From: [REDACTED]
Sent: 10 July 2018 16:38
To: Anita Gardner
Subject: RE: M/64/18/DOC172 Elmer Road

Engineers Responses Relating to Condition 7- surface water drainage

Job No. 1735

CLIENT:	Farndell Builders Ltd
JOB ID:	172 Elmer Road
SCOPE OF WORK:	Soakaway Design
DESIGN CODES AND REFERENCES:	BRE 365
SOFTWARE:	MS EXCEL
SUB-SOIL/ FOUNDATION DATA:	N/A

Percolation test data supplied

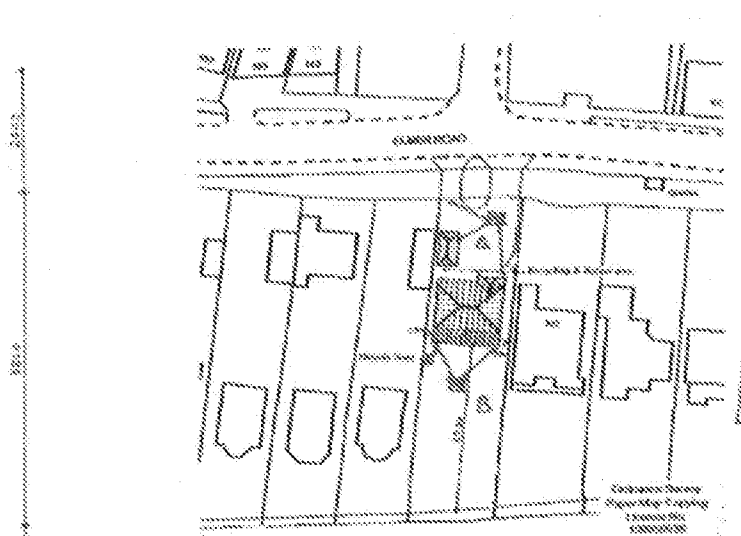
- I am a little confused as to how the infiltration rates have changed between submissions. In the previous submission the lowest rate was $6.07 \times 10^{-6} \text{ms}^{-1}$. Now it has changed to $5.46 \times 10^{-5} \text{ms}^{-1}$. Please can the applicant explain this discrepancy?
The original infiltration rate was incorrectly calculated and based on a different field test. The actual test was a percolation test with the results reported in Vp (mm/sec), the test method and the derivation of infiltration rate is detailed in the calculation together with the test results. And the worst infiltration value has been used which is very conservative as the infiltration rate measured at the location of the soakaway is an order of magnitude greater.

It should also be noted that the lowest recorded infiltration rate should be used, not the average. I.e. please use $6.07 \times 10^{-6} \text{ms}^{-1}$ – Test hole A has the lowest infiltration level. This result has been used for the new calcs.

It should also be noted that the lowest recorded infiltration rate should be used, not the average. I.e. please use $6.07 \times 10^{-6} \text{ms}^{-1}$

Test hole A

$$V_p = 54.91 \text{ sec}$$

$$\text{Infiltration rate, } f = 9.11\text{E-}05 \text{ mm/sec}$$

Test hole B

$$V_p = 11.20 \text{ sec}$$

$$\text{Infiltration rate, } f = 0.000446 \text{ m/sec}$$

Use lowest value in calculation from Test hole A

Crates installed in three layers

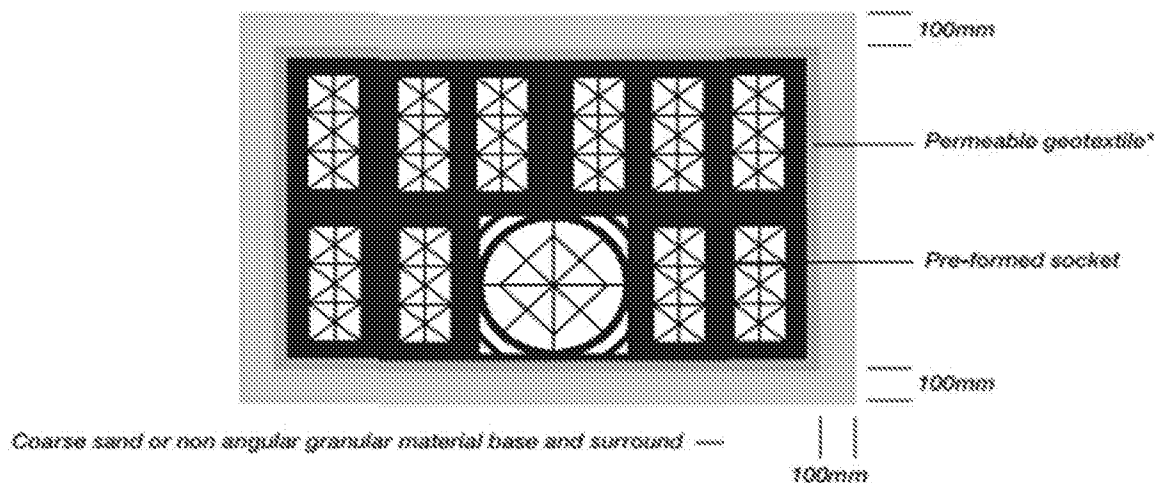
- Manholes need to be provided at the corners of the property where there is a 90 degree change in pipe direction.
- The winter groundwater monitoring was completed in October, therefore not at the peak of groundwater levels. As a result the base of infiltration structures need to be set no lower than 1mbgl.

- Please ensure all infiltration structures are at least 5m from buildings.
We have now re-designed the drainage to account for all four above points. Please see attached.

The design indicates a single soakaway located in the rear garden would be sufficient to cater for run-off from the house and garage.

A typical arrangement using 30 AquaCell or similar crates of 1 x 0.5 x 0.4 (high) installed in the rear garden in accordance with manufacturers recommendations.
